**ADDENDUM NUMBER 2**

**Project:** Additions and Renovations to  
Washington County VA Sheriff's Office  
CC Porter Animal Shelter  
27252 Porter Lane  
Abingdon, VA 24211

**Date:** September 16, 2021

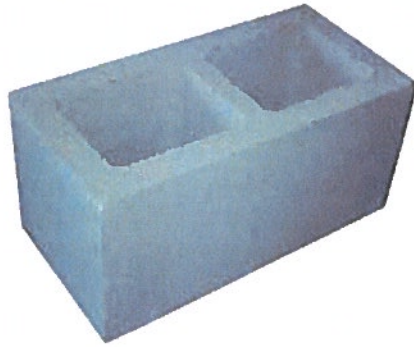
2. **Refer to Drawings A301, "Building Section" and A302, "Wall Section":** Are jamb blocks required at kennel door masonry openings and at the "fenced window" indicated by keynote #13 on Drawing A302?

Architect has incorrectly referred to the block at these masonry openings as "jamb block." The intent is to utilize a solid end block that is sometimes referred to as a "pillar block." See photo example of type of block intended at these masonry openings.

## ROOF FRAMING PLAN

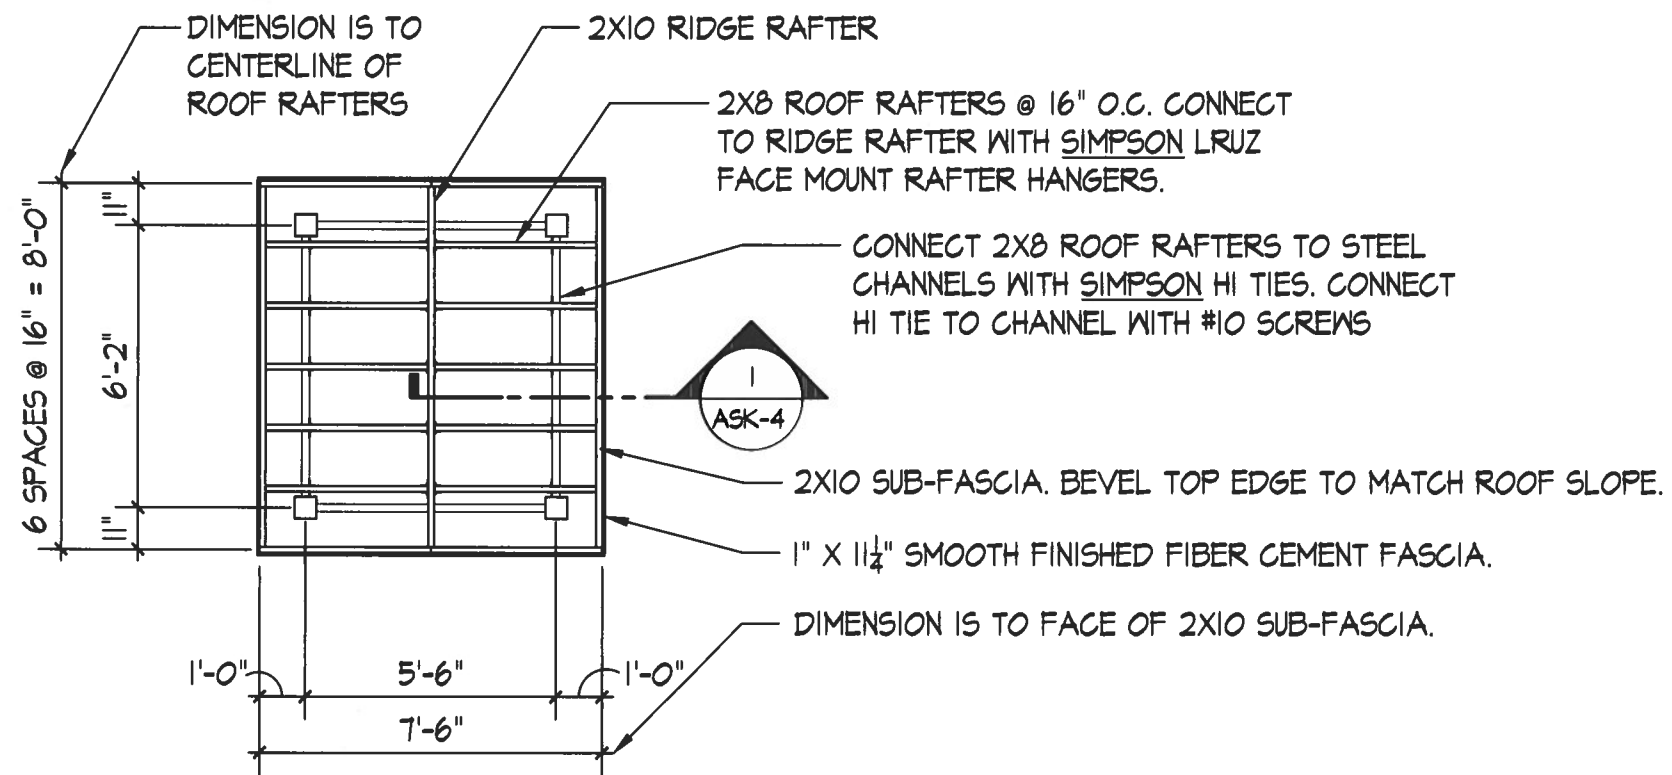
3. **Refer to Drawing A501, "Stair Plan / Stair Details":** Bidder requests stair roof framing plan for 2 x 8 rafters and Simpson H1 attachment to C8.

Drawings ASK-3 and ASK-4 are provided to clarify architect's intent.
